# ① About soft start

② About burst mode threshold

Figure 29. Feedback Chain Timing Diagram

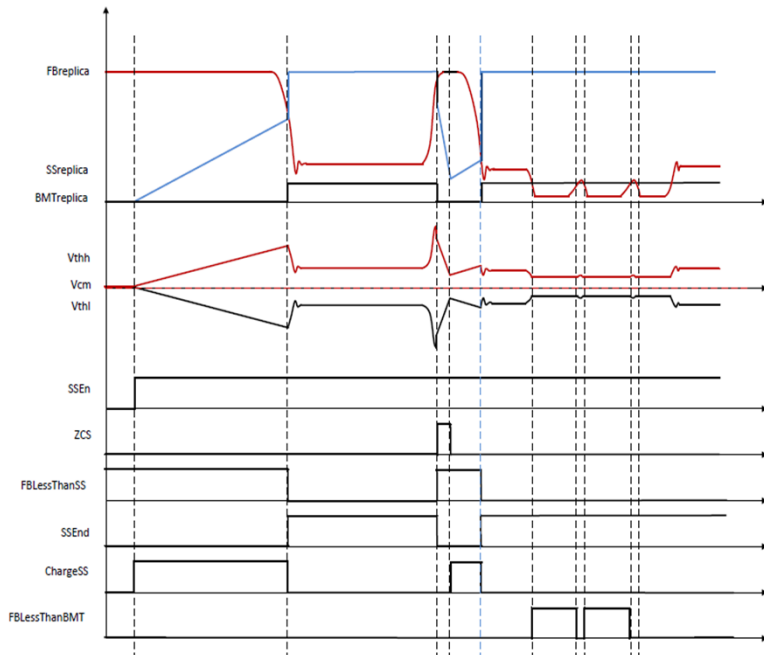
Looking at the above timing of the data sheet, SSEnd goes High when Ssreplica becomes higher than FBReplica. Soft start has ended at this time.

1 Ssreplica ＝ LL/SS Voltage
   Fbreplica ＝ FB Voltage
   Is this correct?

2CH:LL/SS

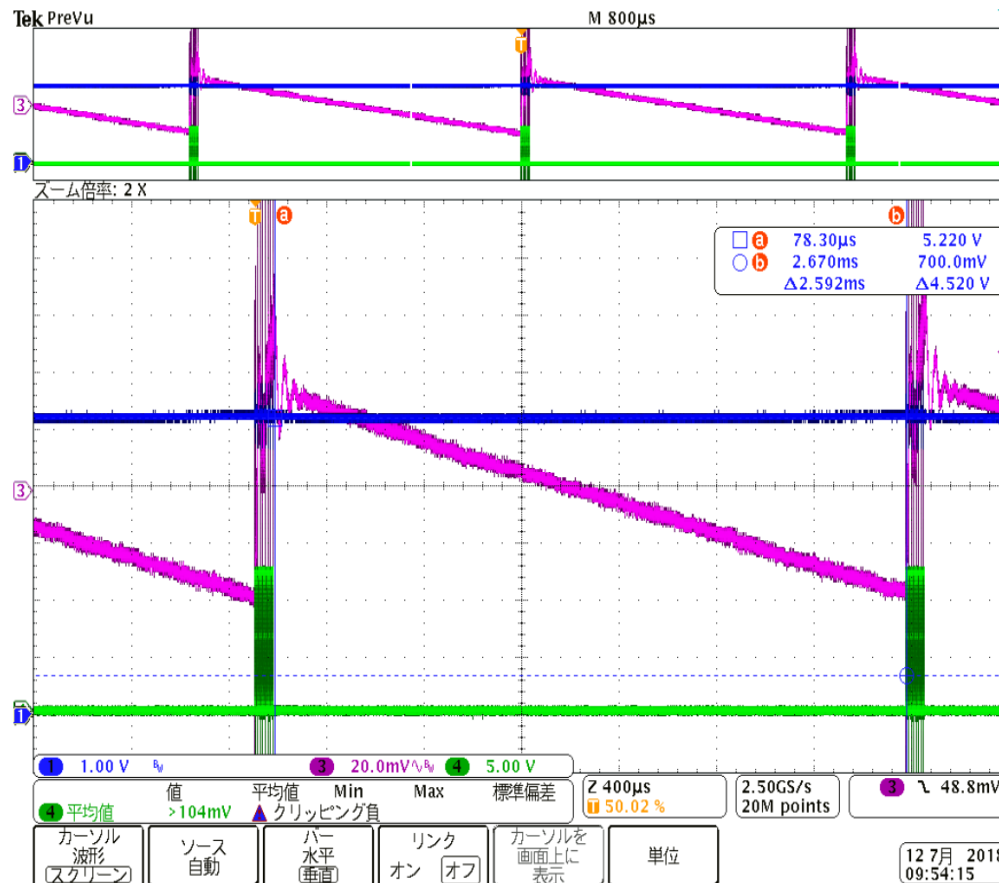
End soft start?

2 The upper waveform (under evaluation) is FB> LL / SS. It seems that soft-start has ended.
Is the behavior of this waveform correct?
(I think it is different from the operation described in the data sheet.)

3 In addition, the sending start is over in the above part.
Is this correct in your understanding?

1ch-Blue: V_FB
3ch-Pink: Vo
4ch-Green: L-INV_Vgs

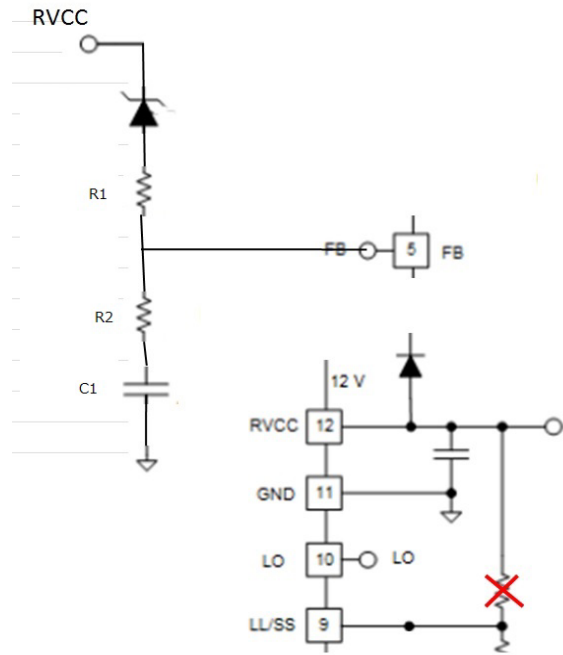
The waveform is performing burst operation at no load.
RLLupper（Terminal Upper Resistance)=open.

VLL(Burst threshold voltage)=0.7V(min)
When the FB voltage falls below VLL, the burst operation starts.
State of FB voltage> 0.7 V. However, I think that the burst operation state.
why?
What is the reason for this?
